*Proposed Bowdens Mine SSD 5765
Surface Water Submission Report to the
Independent Planning Commission*

On behalf of the Lue Action Group

By Shireen Baguley

Bowdens intends to harvest more twice its entitlements

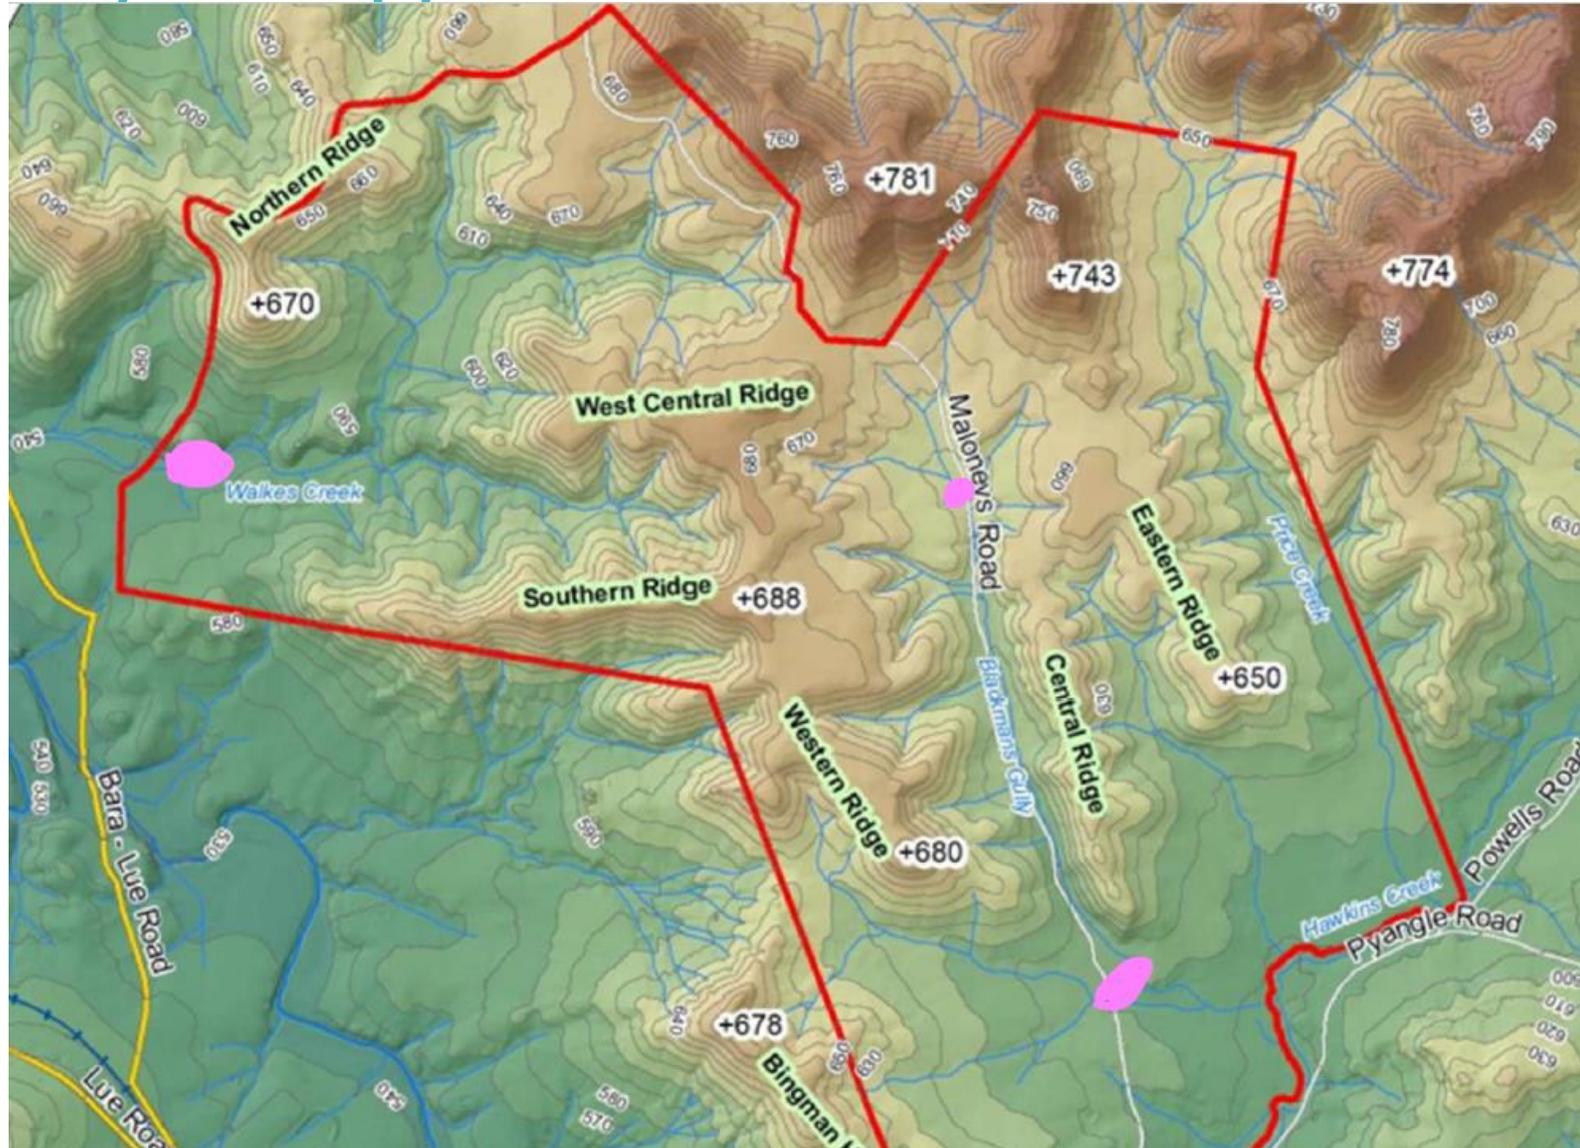
186.1ML is the maximum volume of dams allowed, however already 59 dams across the 2580ha property. Assumed average of 1.5m = 72ML.

Remaining harvestable right of only **114ML**

Exemptions being relied on for these dams require these to be on minor streams
